Re: Incorrect Thermal broken Aluminum Joinery: 2 Rapare St. Job No.27363 - JSR Construction.

- a) Photo 1 – Indicating the non-thermally broken parts of the Sliding Door “Lounge D6” (Door number referred to the attached quote no. 27363) (Trim Size: 2130 x 2700; Area: 5.751 m sq.)

Photo 3 – Typical slide door frame shows that the slide door does not have thermally broken

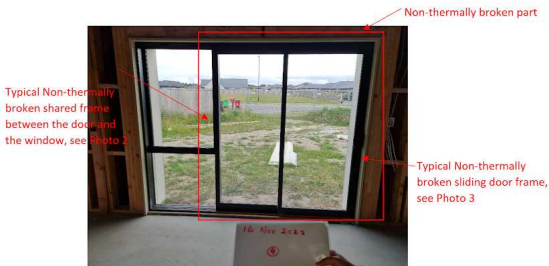
1. All the stiles of the sliding doors are not thermally broken (referring to the photo 3 in my email on Nov 20, 2022 at 10:06 PM)
2. All the fixed interlockers of the sliding doors are missed a thermally-broken strip (referring to the photo 2 in my email on Nov 20, 2022 at 10:06 PM). Note that these fixed interlockers are also a part of the adjacent windows.

- c) Photo 3 – Typical slide door frame shows that the slide door does not have thermally broken strip
 - d) Photo 4 – Indicating the non-thermally broken parts of the Sliding Door “Living D6” (Door number referred to the attached quote no. 27363) (Trim Size: 2130 x 2700; Area: 5.751 m sq.)

Photo 2 – Typical joint between the vertical frame of the sliding door and the horizontal frame of the window shows that the shared frame between the door and the window do not have the thermally broken strip.

You are requested to replace all the entire windows and doors which are partially non thermally broken. The warranty of the affected products has to be valid after the replacement.

Figure 1 - Photo location plan

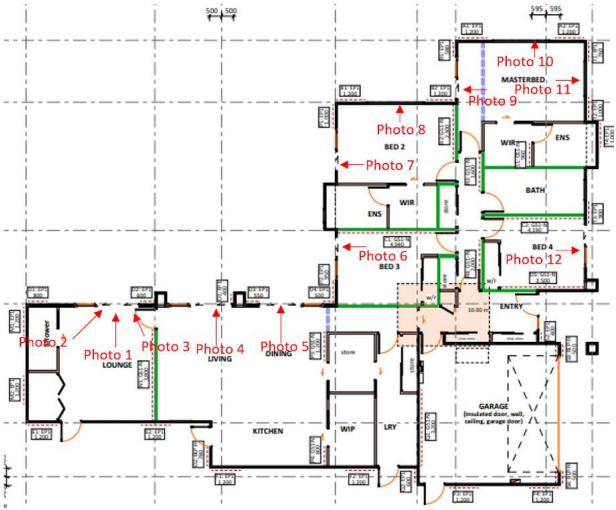
- 1) The parts of the windows and doors frames do not have the thermally broken strip. These windows and doors make up 59% of the area of all the joinery products. The total area of these problematic aluminium joinery is 28.8 m sq. The total area of all aluminium joinery products is 48.6 m sq. These products are shown in the following photos (note that the photos and the location plan are given at the end of this email):

- 2) The frames of the windows that we are not sure if they are thermally broken or not since the depths of those window frames seems to be different from others 32% of the thermally broken joinery by comparing the distances between the frames and the internal and external walls. The total area of the aluminium joinery is 4.2 m sq. (8.7 % of the total area). These products are shown in the following photos:
